Item 20-22: Sign Policy for “PUSH OR WAVE AT” sign

Recommendation: Revise the CA MUTCD to include policy on new touch-free pedestrian sign.

Requesting Agency / Sponsor: Caltrans / Monica Kress-Wooster, CTCDC Voting member

R10-3j (CA)

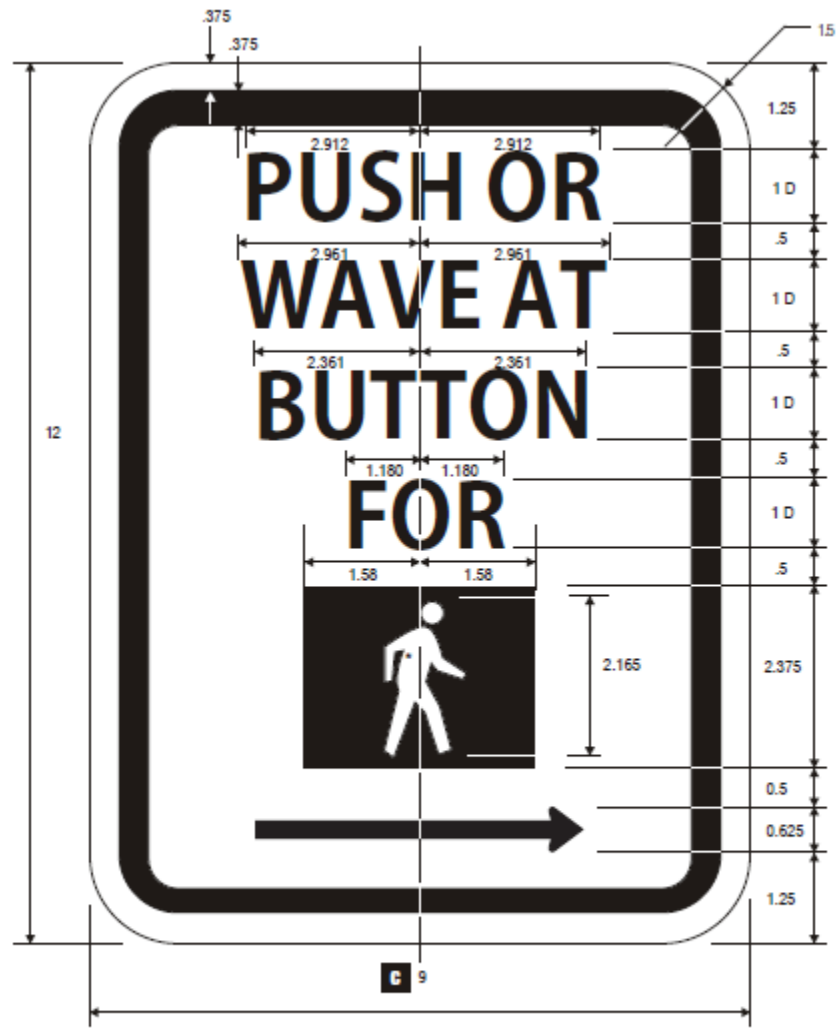
~~06b~~ The R10-3j(CA) sign may be used where the pedestrian signal can be activated by pushing the button or waving at the button.

~~06d~~ The bottom panels of signs ~~R10-3b through R10-3e(CA)~~ and R10-3i(CA) shall be eliminated where the pedestrian signal timing is non-actuated and the pedestrian push button is used solely to activate accessible pedestrian signals.
